Change of contents

FCC ID : PP4PX-800

Before change(picture)	After change(picture)

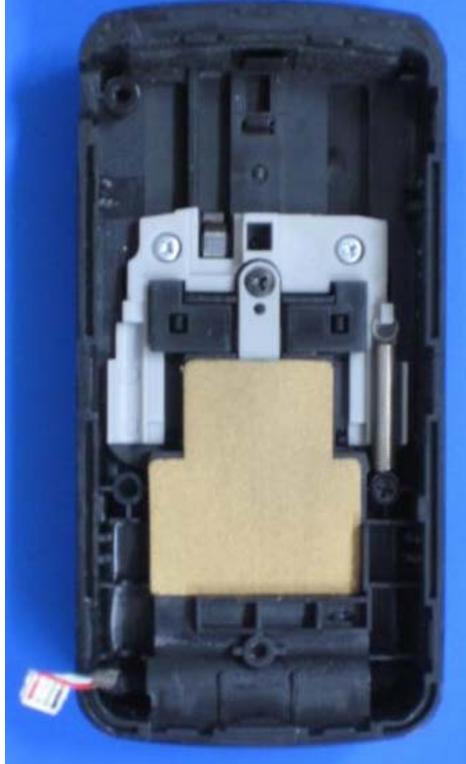
Before change(explanation) <ol style="list-style-type: none">1. Operated Cell, PCS and AWS.2. Used EMI.	After change(explanation) <ol style="list-style-type: none">1. Operated Cell and PCS. (Be out of AWS BAND by the software)2. Deleted EMI.3. Changed MAIN antenna & SUB Antenna.
